WEST SUSSEX COUNTY COUNCIL CONSULTATION

| LOCATION: | Land rear of Meadow Way including 24 Meadow Way Westergate |
| SUBJECT: | AL/137/24/RES Approval of reserved matters following outline consent AL/178/22/OUT for appearance, landscaping, layout and scale for 89 No. dwellings with open space and associated works (resubmission following AL/50/24/RES). This application is in CIL Zone 3 and is CIL Liable as new dwellings. |
| RECOMMENDATION: | Modification |

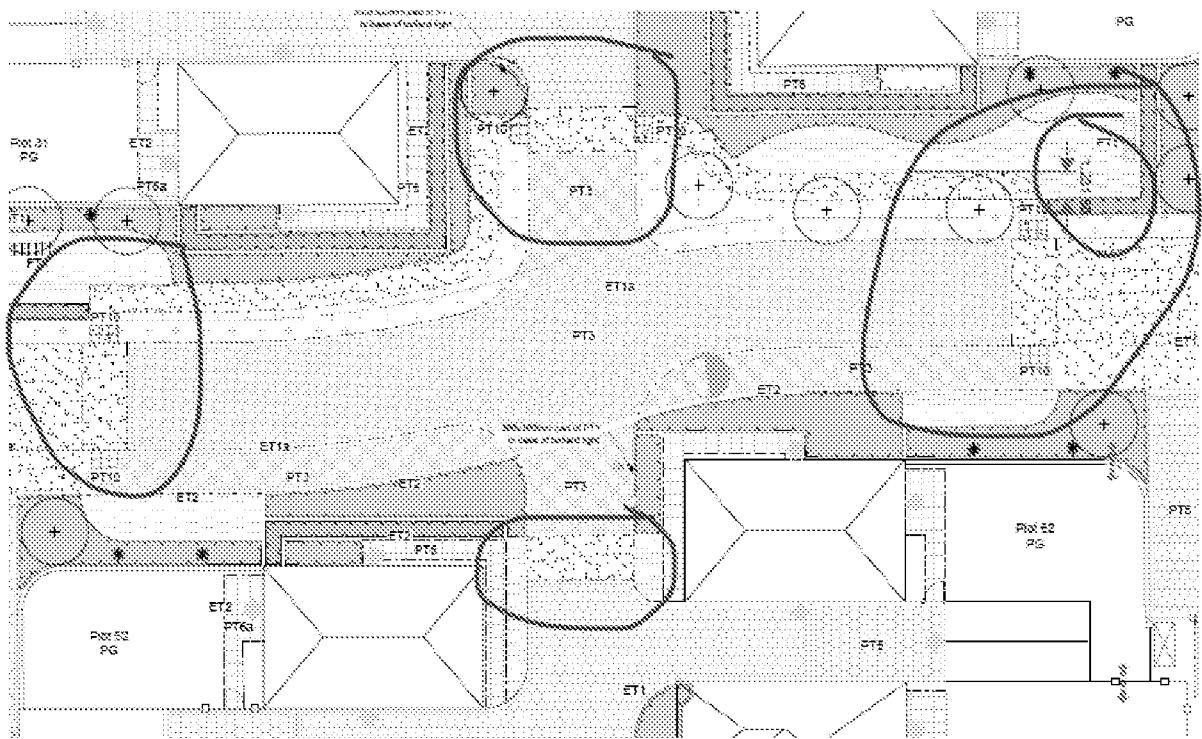
7. For example, the road adjacent to plot 14 uses a different surface treatment for an access driveway but has a footway on the left-hand side up to the disabled car parking spaces. WSCC would recommend where there is a footway on one side it should also have a tarmac road adjacent to this to keep the continuity.

8. WSCC would recommend this has a tarmac road surface until the end of the footway which can be dropped down into a shared surface road with tactile paving before the disabled parking spaces.

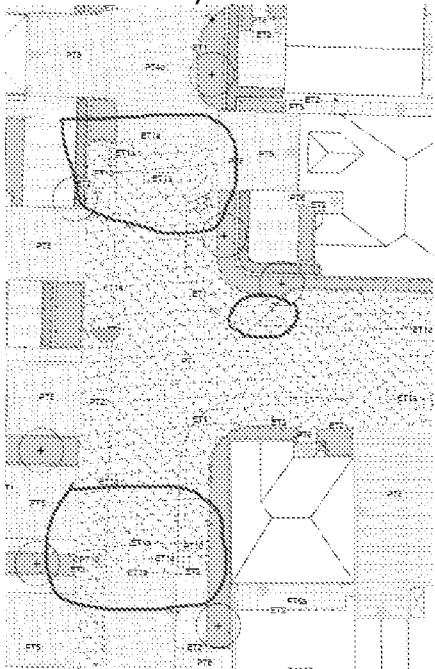
11. The traffic calming zone in the centre of the site is welcomed to break up the long length of road and provide a focal point however we are concerned over the width of the paths proposed to the north of the zone.

12. The footpath on the northern side is only 1.2m wide which is very narrow. WSSC recommend a minimum of 1.5m. The surface treatment used here is also not consistent and it is not clear why you would have a strip of tarmac between surfaces on the north and south access.

13. If you're entering into a shared surface the material used should be consistent. See below.
14. The access into the cul-de-sac in between plots 52 and 62 would not be clear to someone who is visually or mobility impaired as the footway takes them across the access and doesn't help them into the shared space.
